ALNRC 00025
May 15, 2009

Enclosure F

Red-line strikeout changes to Sections 1.2, 2.2.2, 3.7 and 5.1 of the ER

Figure 3.7-1—Callaway Plant Unit 2 345 kV Circuit Corridors

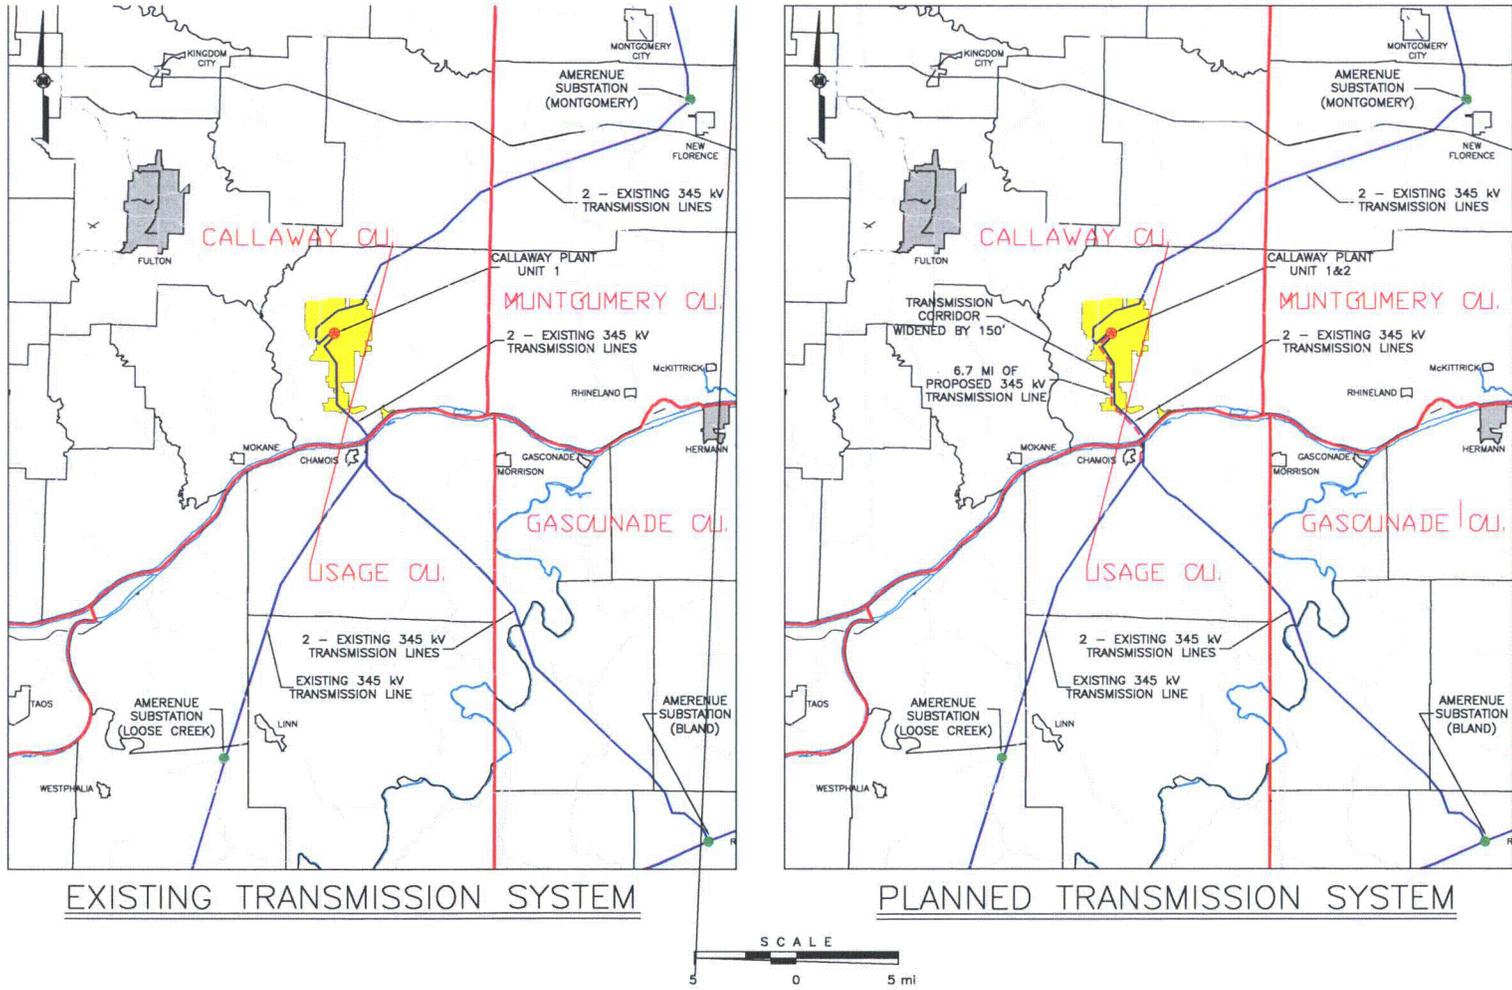
The existing transmission system, constructed and operated for Callaway Plant Unit 1, was addressed in the Environmental Statement submitted with the original plant license application (UEC, 1975). The existing transmission system consists of two 345 kV circuits from the Montgomery Substation about 21 miles (34 km) to the northeast near New Florence, and a 345 kV circuit from the Bland Substation, approximately 29 miles (47km) to the south near Owensville, and a 345kV circuit from the Loose Creek Substation approximately 17 miles (27.4km) to the south near Linn. The Bland Substation is located on the south side of the 345-kV Labadie-Franks-3 transmission line right-of-way, north of Owensville, Missouri and west of State Highway 19, and is about 29 airline miles (47 km) to the south of the plant. This arrangement provides two physically-separated offsite transmission lines comprised of ~~three~~four 345 kV circuits. ~~The nearest distance between a Bland and a Montgomery line is the point where they attach to the switchyard arbors. The distance between the outside phases of these lines at this point will be approximately 1,300 ft (396 m).~~ The existing transmission system will not be addressed in this section, except where it impacts or is impacted by the transmission facilities of Callaway Plant Unit 2. The routes for the existing two 345 kV circuits from the Callaway Plant site to the Montgomery Substation, and the single 345 kV circuit from the Callaway Plant site to the Bland Substation, and the single 345kV circuit from the Callaway Plant Site to the Loose Creek Substation ~~Generating Station~~ are presented in Figure 3.7-1.

Figure 3.7-2—Callaway Plant Unit 2 Topography and Switchyard Interconnection

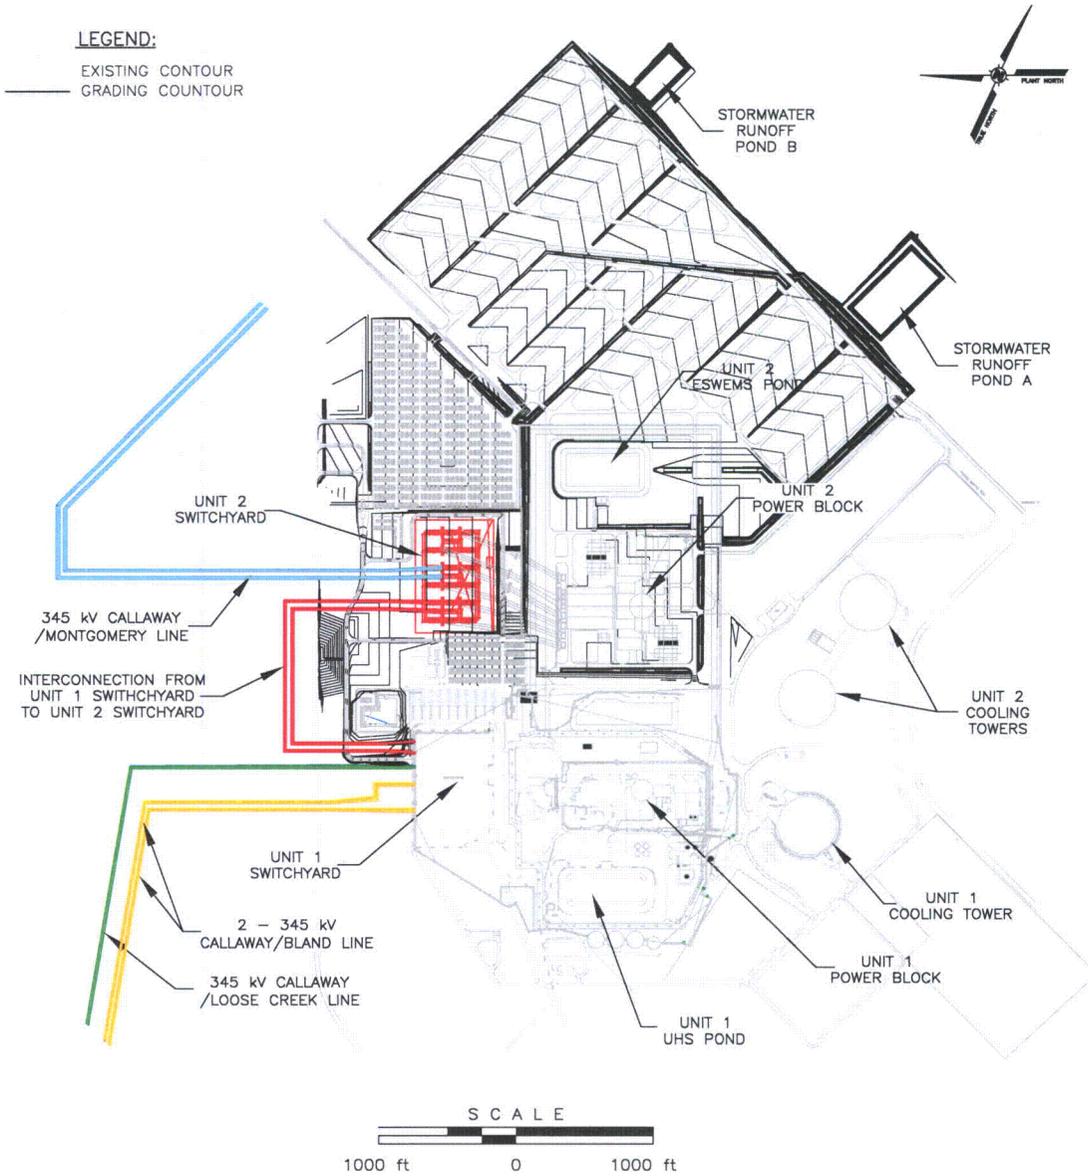
The Callaway Plant Unit 2 switchyard is electrically integrated with the existing Callaway Plant Unit 1, 345 kV, switchyard by constructing two approximately 1 mile (1.6 km), 345 kV, 2,090 MVA lines on common towers. A topographic map showing the location of the connecting circuits between the two switchyards is presented in Figure 3.7-2.

As shown in Figure 3.7-2, the proposed Callaway Plant Unit 2 switchyard and transmission lines connecting the Callaway Plant Unit 2 switchyard to the existing Callaway Plant Unit 1 switchyard would be constructed entirely on the Callaway Plant site. The new portion of the Callaway-Loose Creek line would be constructed on the existing Callaway-Bland right-of-way. Therefore all newly constructed transmission systems will be contained in AmerenUE owned property or on existing easements.
